**West Vaughan Sewage System
Environmental Study Report
Addendum**

The Regional Municipality of York

Contract P-13-43

January 2016

Figure 1: West Vaughan Sewage System Project, Original and Proposed Alignment

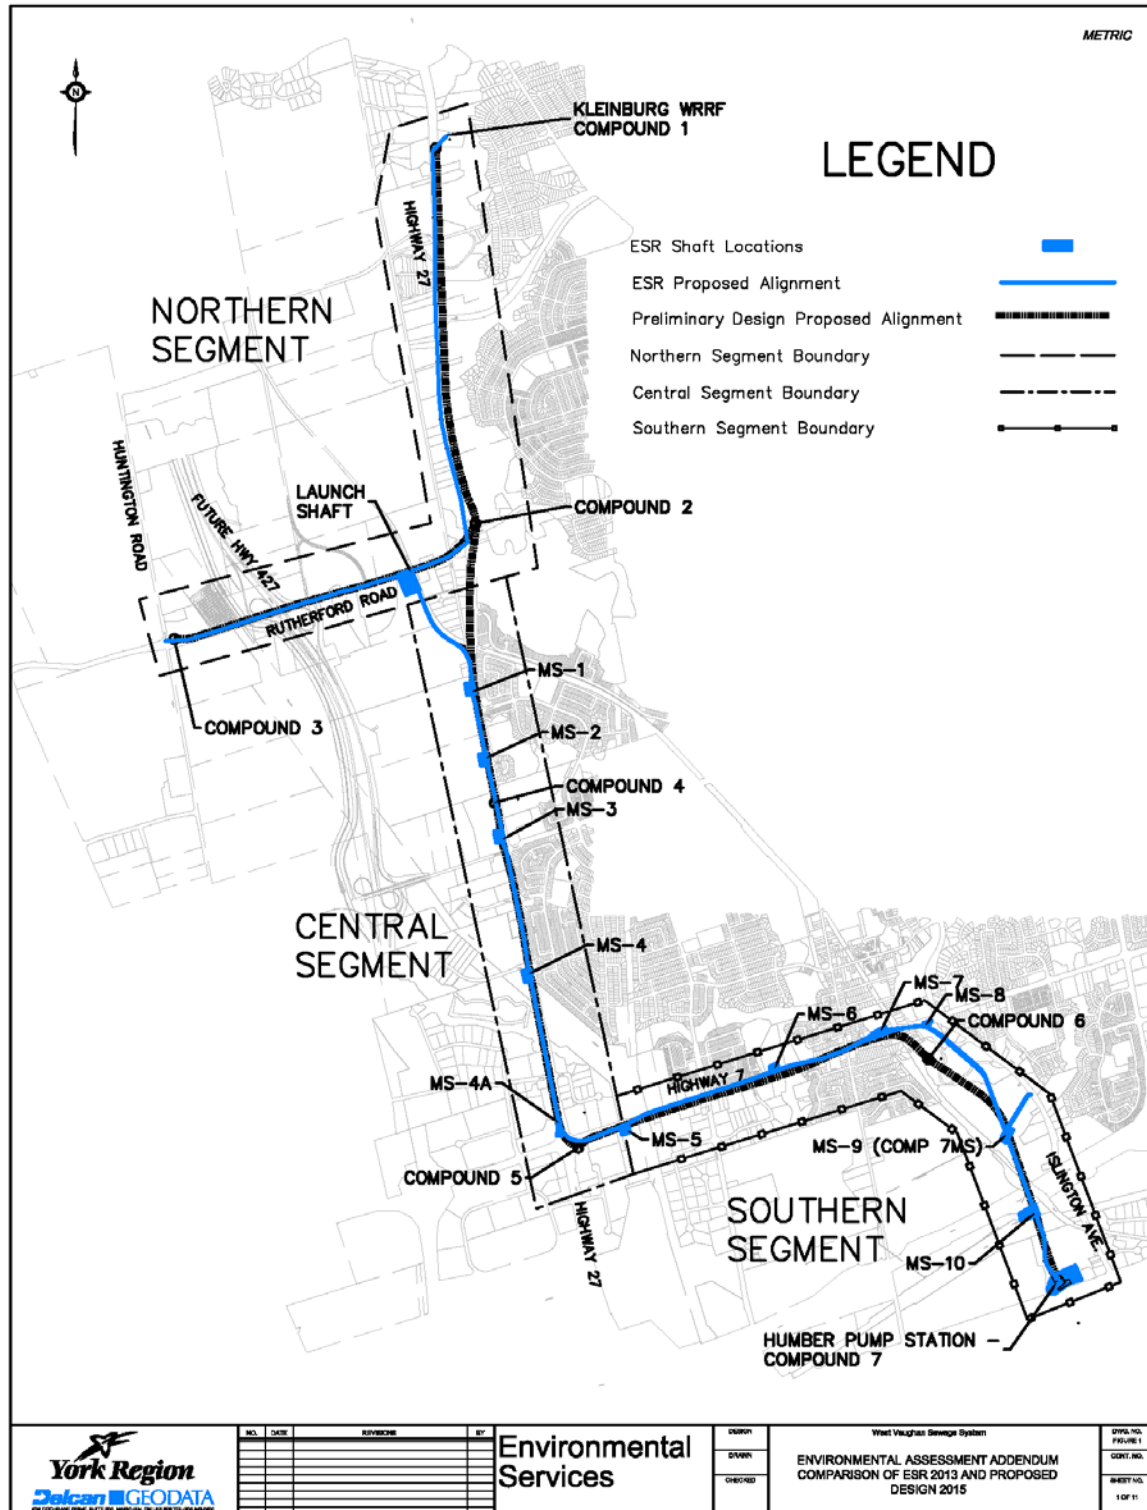
Following the filing of the ESR for the WVSS Project, proposed modifications were identified during the preliminary design phase that are intended to improve the tunnel alignment while reducing actual or potential impacts to the environment. The proposed modifications decreased the number of maintenance and microtunneling shafts required by using a larger, three-metre diameter Tunnel Boring Machine (TBM) for all sewer segments. In general, project modifications include:

Figure 1 depicts the original ESR Proposed Alignment and the modified alignment (“Preliminary Design Proposed Alignment”) of the sewer tunnel and shaft locations. The maintenance shafts (MS) illustrate the original ESR shaft locations and the compounds depict the shaft locations for the Preliminary Design Proposed Alignment. The microtunneling shafts, which are smaller and shallower than the maintenance shafts, are not shown on the Figure for clarity, but would typically have been spaced approximately 200 metres apart along the alignment. Note that the Northern and Western Segments were combined into the Northern Segment, due to similarities in the new alignment.

Figure 3: Compound 3 Site Plan, Rutherford Road at Huntington Road

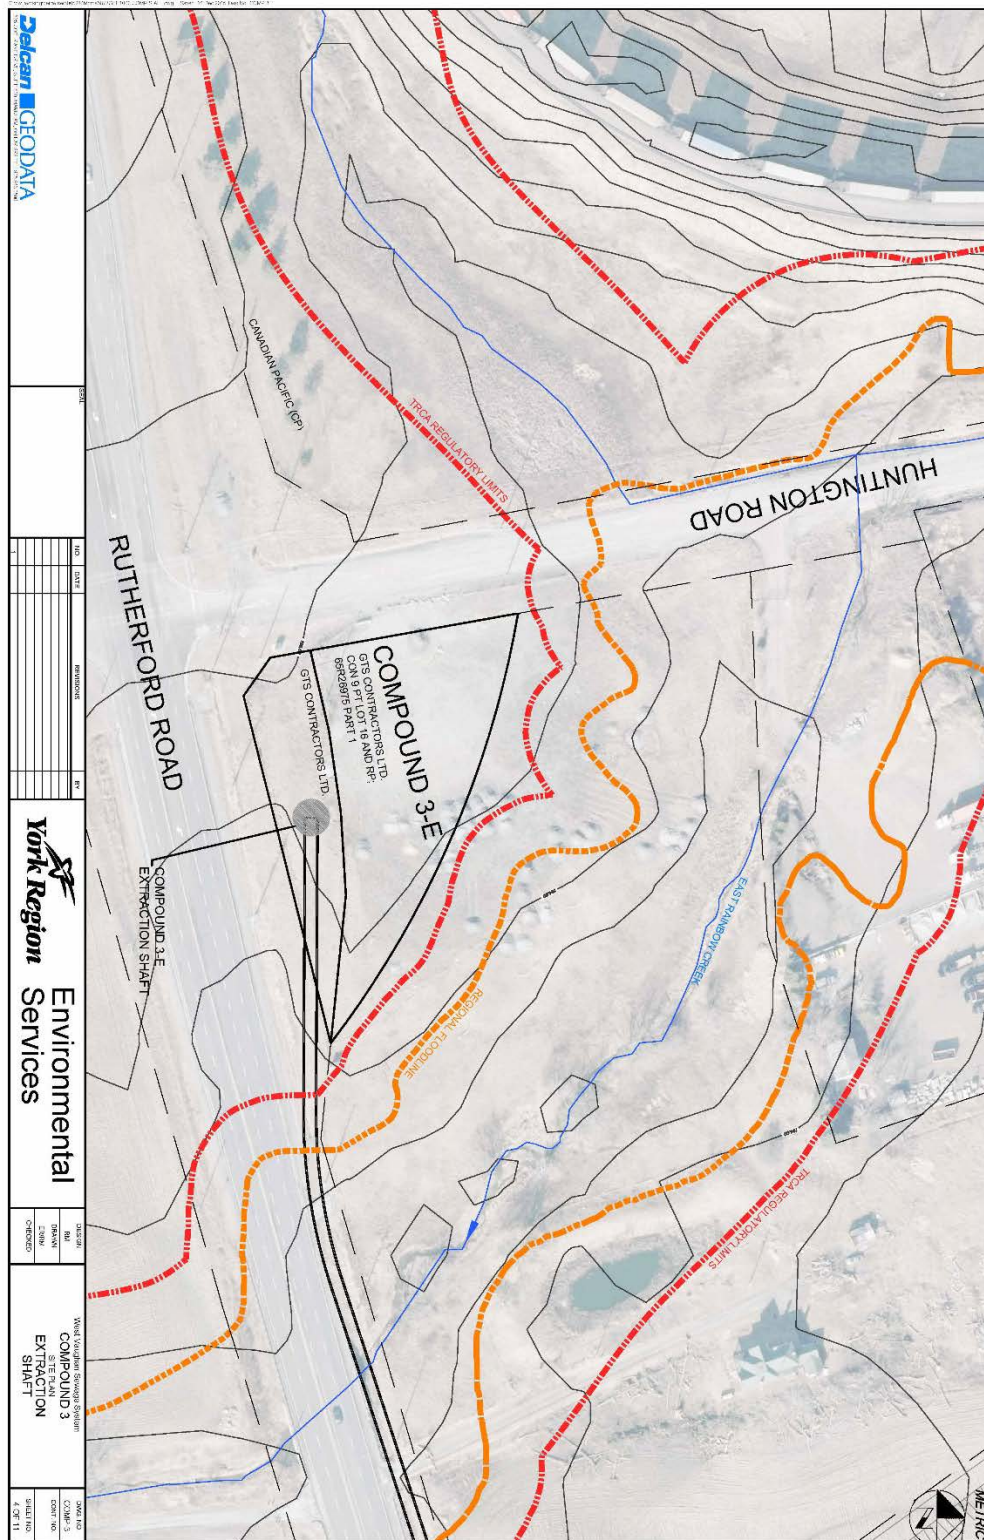
Compound 3 ([Figure 3](#)) is proposed to be located on the same Rutherford Road parcel at the Rutherford Road / Huntington Road intersection as indicated in the ESR. This parcel, located on private property, requires a permanent easement to accommodate the shaft. Compound 3 will also require adjacent property for temporary staging during construction, which was not identified in the ESR.

Figure 5: Compound 5 Site Plan, Highway 27 at Highway 7

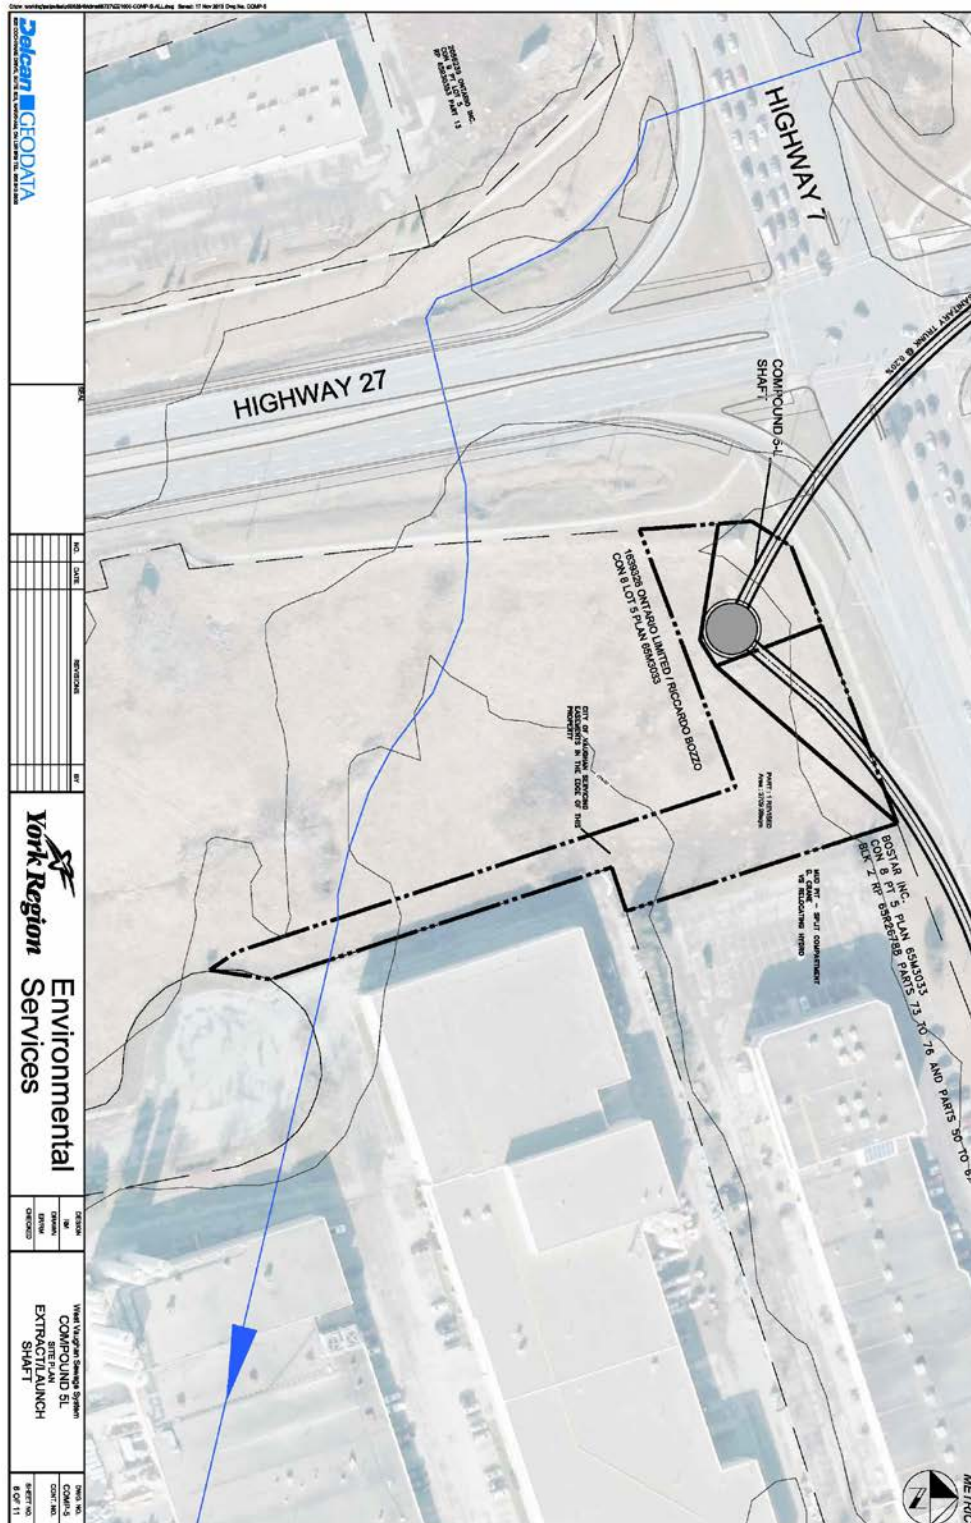
Shafts at Compounds 2, 5, and 6 will be located on property that was not previously identified in the ESR. Compound 2, shown in [Figure 2](#), will be located adjacent to the Highway 27 right-of-way owned by the City of Vaughan. Compound 5, depicted in [Figure 5](#), will be located on private property adjacent to Highway 27 and Highway 7. Compound 6, depicted in [Figure 6](#), will be located on private property south of Wallace Street.

Figure 6a: Compound 6a Site Plan, Wallace Street (Preferred Option)

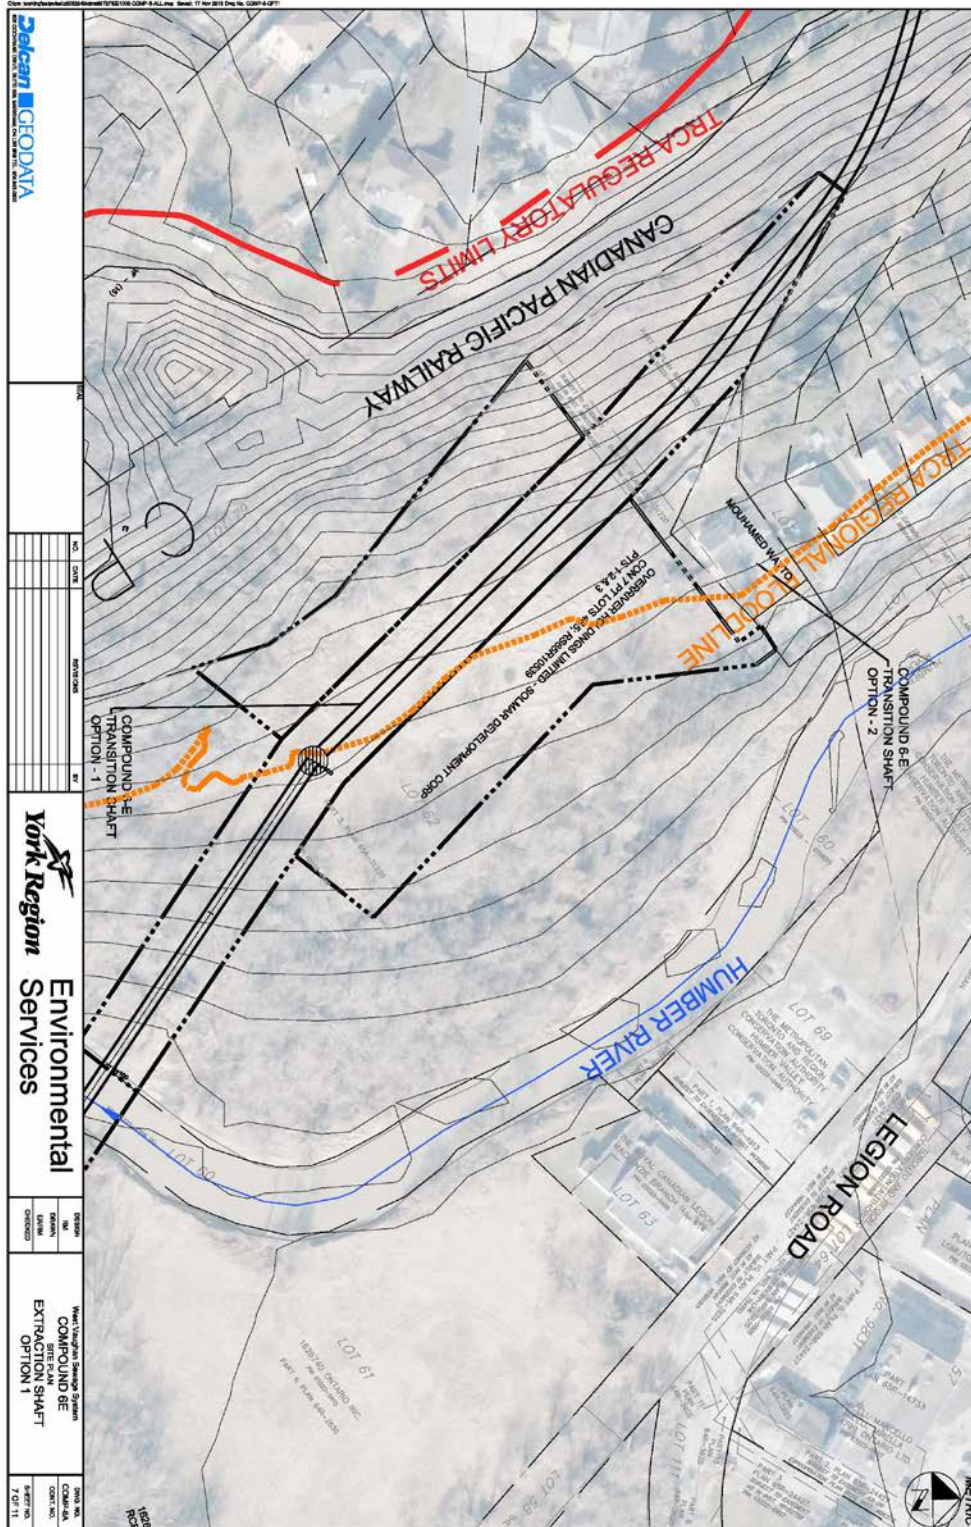
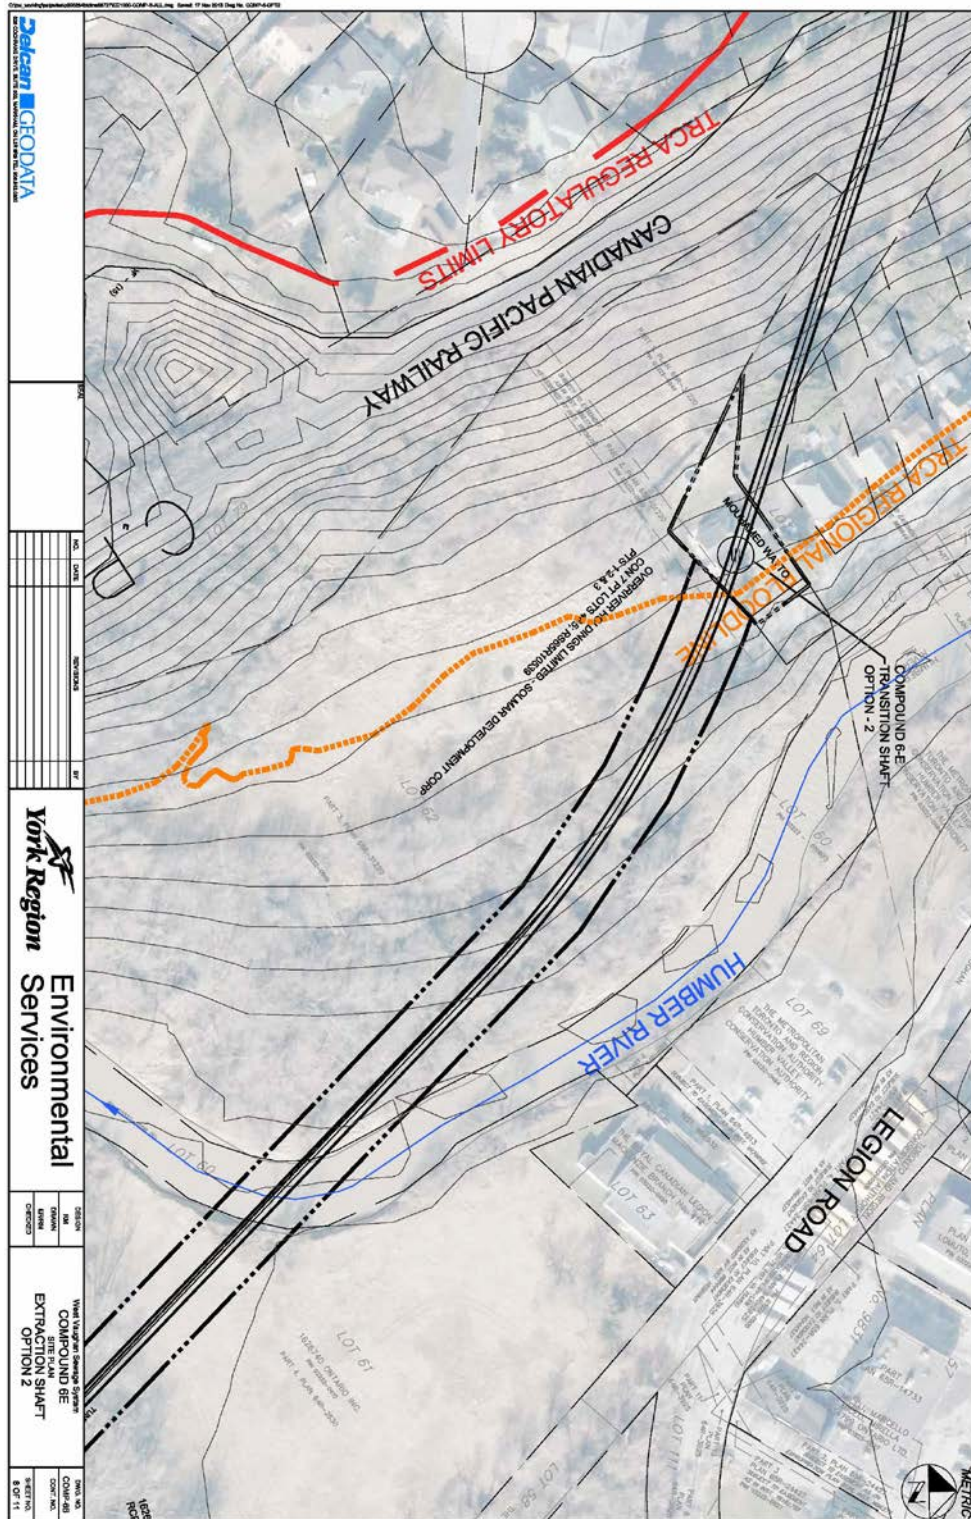
[Figures 6a and 6b](#) depict the property acquisition required for the two options: Compound 6a and 6b. As a result of tunnel alignment modifications to reduce the risk of constructing under the Highway 7 bridge over the Humber River, the Region relocated the alignment to run to the

west and south of Wallace Street. This will require an extraction shaft to be constructed on property south of Wallace Street. Permanent property is needed for either shaft site. The preferred alignment is Compound 6a. If the Region is not able to resolve land acquisition for this parcel, then option Compound 6b would be pursued.

Figure 7: Compound 7 at the Humber Pumping Station

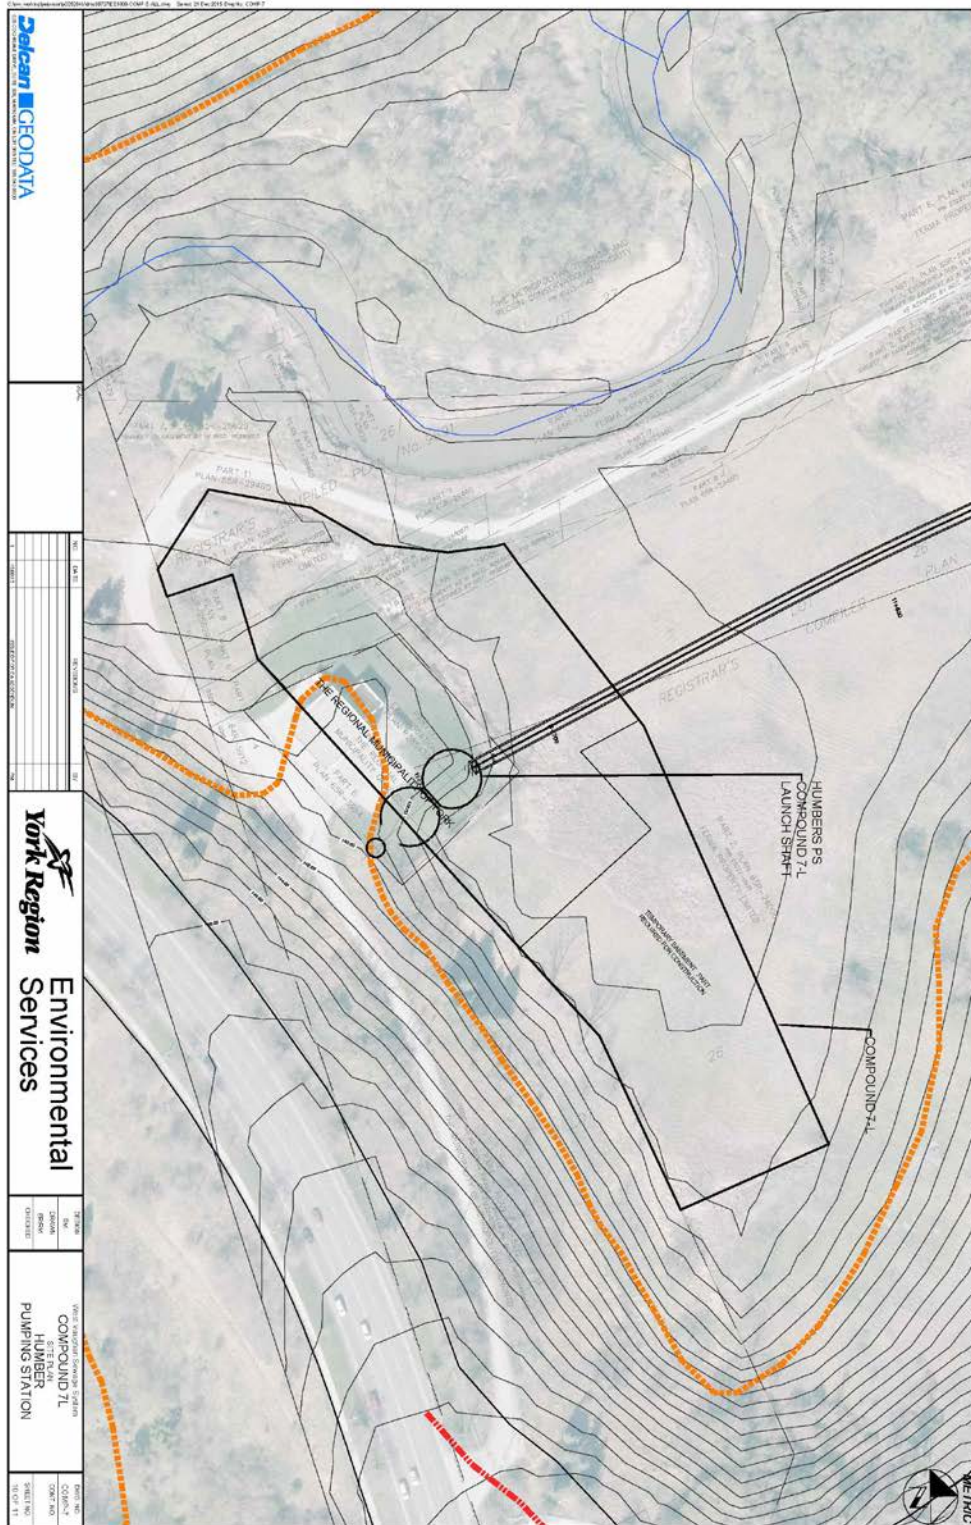
Figure 7 depicts the property acquisition required around Compound 7 at the Humber PS. The ESR previously identified a temporary easement around the Humber PS for construction of the tunnel and pump station. The ESR also identified private land that would be permanently required adjacent to the existing Humber PS property. As a result of the tunnel alignment modifications, the Region will be required to expand the permanent property needed around the pump station, although the temporary easement limits would remain unchanged.
